**Subject:** RE: MP09\_0167 MOD4, 45 Maquarie Street - removal of lightning masts

**From:** Jesse Cheung [<mailto:JesseCheung@crownsgroup.com.au>]  
**Sent:** Friday, 8 May 2015 10:26 AM  
**To:** Matthew Rosel  
**Cc:** André Szczepanski  
**Subject:** Lightning Masts for V

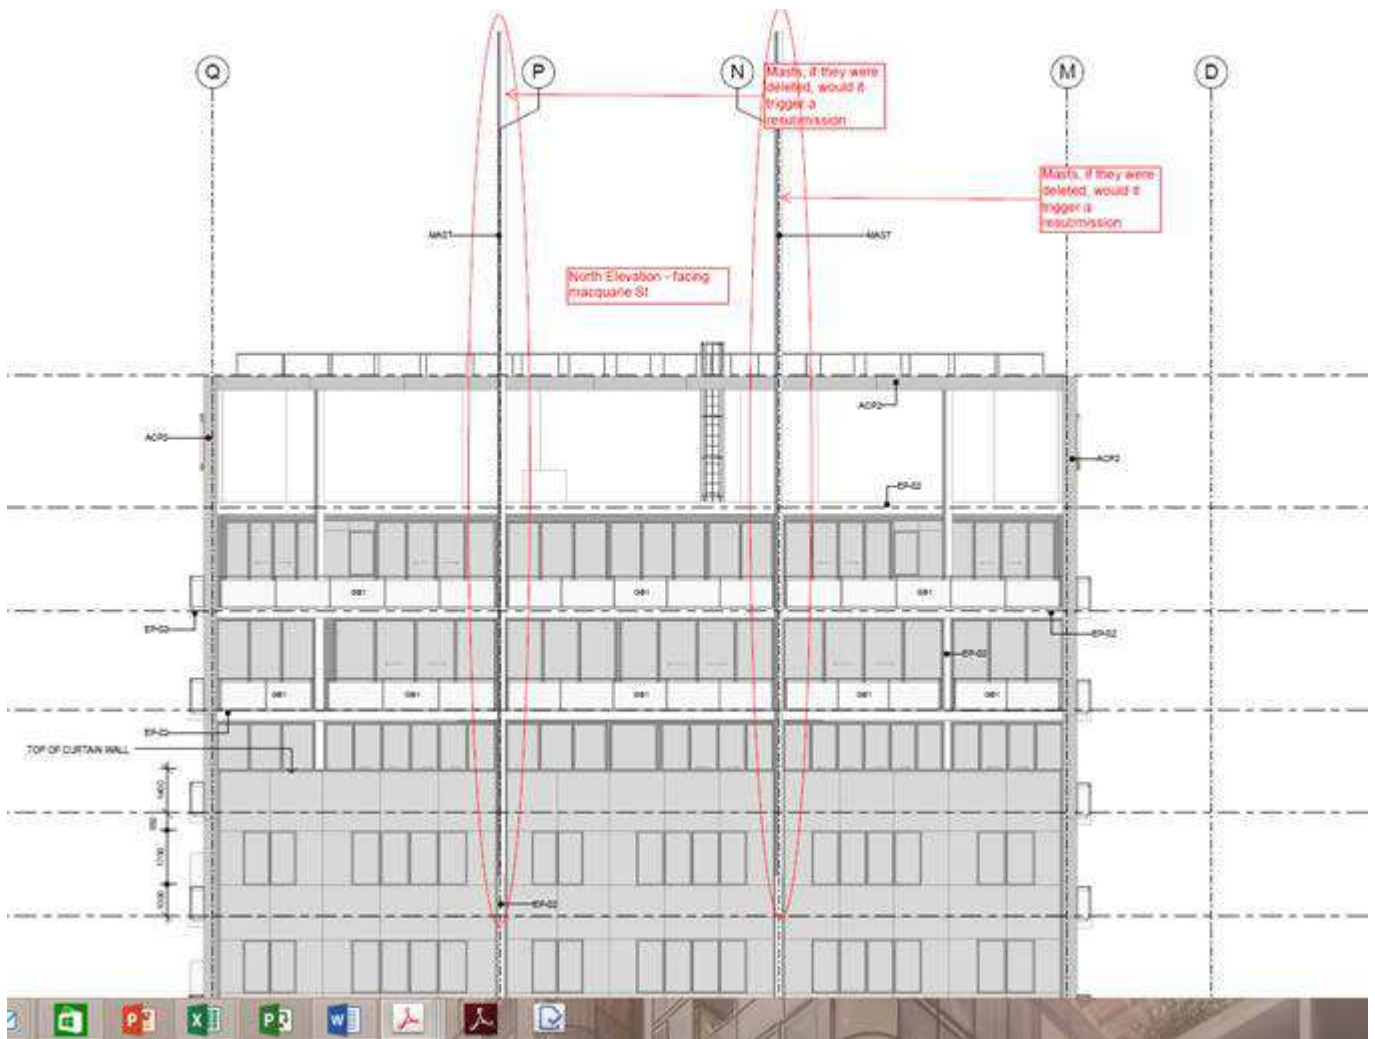
If we were to take off the lightning masts for V Parramatta would this trigger another S75W or trigger a resubmission/re-exhibition or can we submit this as part of the addendum?

(below there is an outline of the diagram of what we are proposing) as well as some reasons why:

- Safety (construction risk associated with building this detail). We can get some dot points from CP/Steve/Richard
- Original design intent was for these masts/blades to act as lightning conductors however due to technological advancements since the design was approved these are no longer required for this purpose and lightning conductors have been set up somewhere else in the building.
- This improves/reduces the impact of the building when view from Parramatta park as it reduces height and the building is less prominent once these blades/masts.

We have now had a chance to look at your request to remove the lightning masts from the 45 Maquarie St proposal. I can confirm that the proposed change would not trigger another S75W application, so if you wish to pursue this alteration you can submit the details as part of an addendum.
